ADA Curb Ramp New Construction Inspection Form (Perpendicular)

Nw 291 st

23885.56

Nw fair st

PERPENDICULAR RAMP (PR)

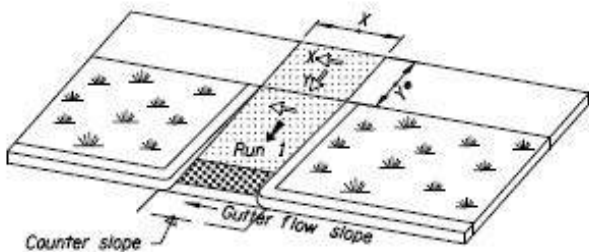
Tool joint in turn space rr1 icrr
